CITY OF STAR

LAND USE STAFF REPORT

FILE(S) #: FP-24-08, Final Plat, Oliver Estates Subdivision

**RE: Oliver Estates Subdivision
Improvement Drawings—Submittal 1**

Oliver Estates Subdivision No. 1

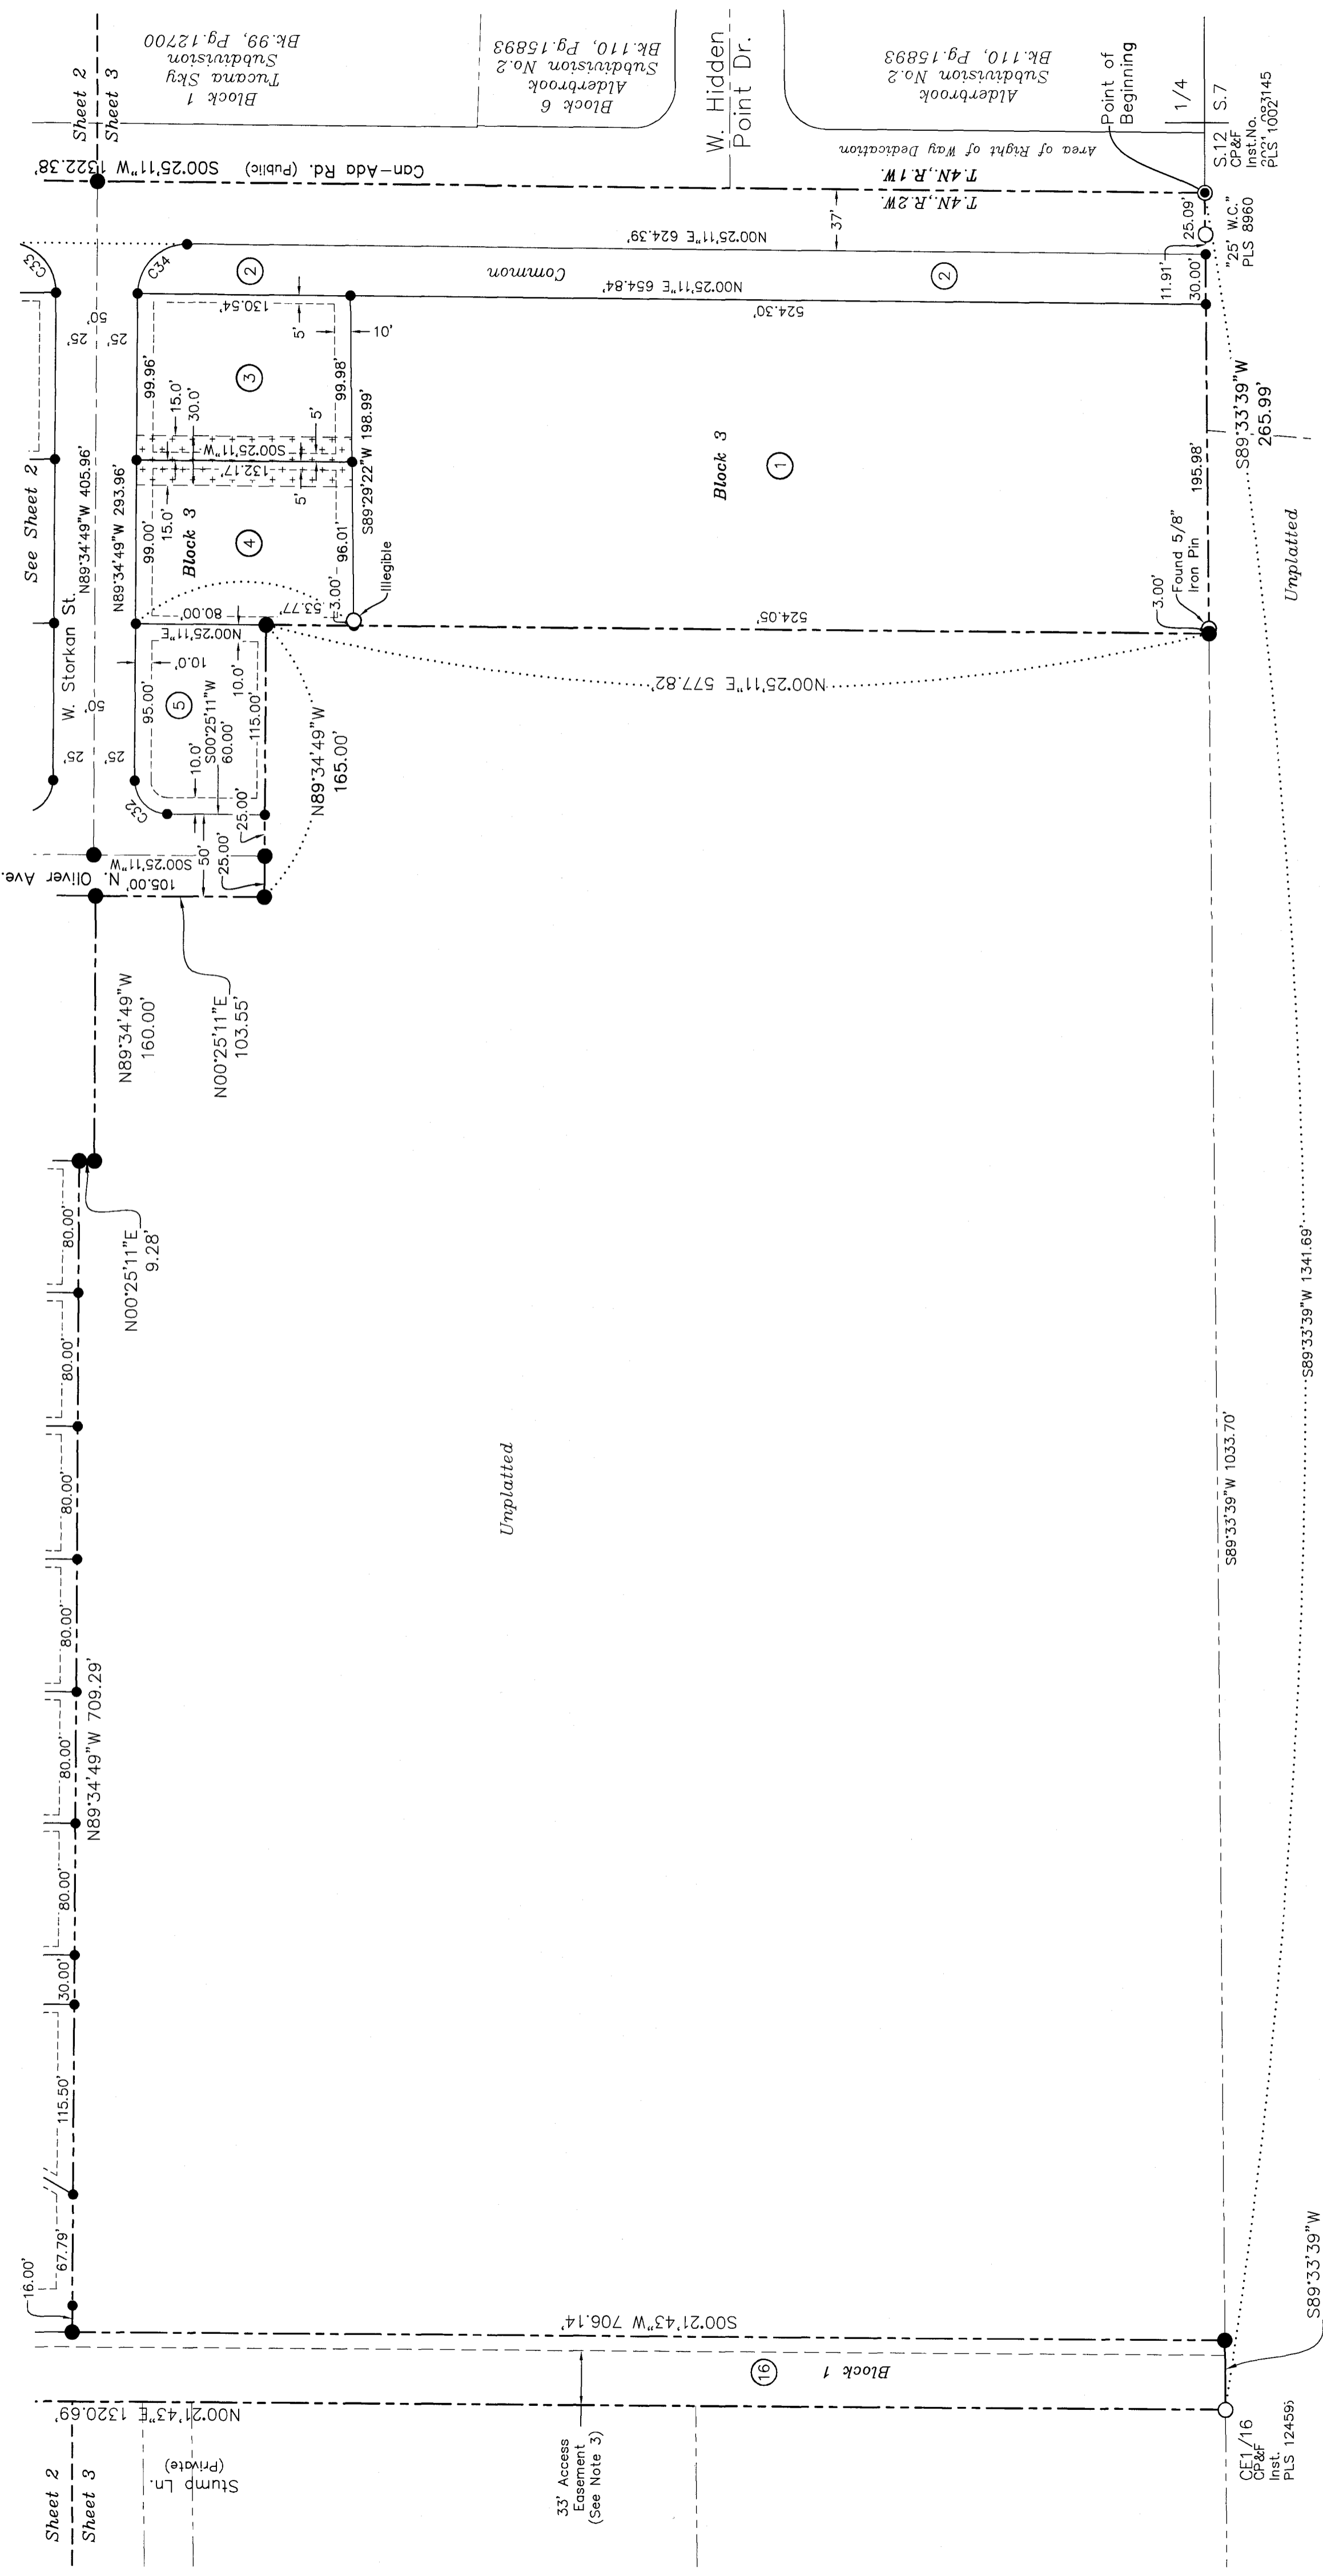
1. L1, Line table missing. Please add dimension
2. 1"=70' scale is cumbersome. Consider different scale
3. Revise Notes:
 - a. Common Lot Block 1 Lot 16= ROW
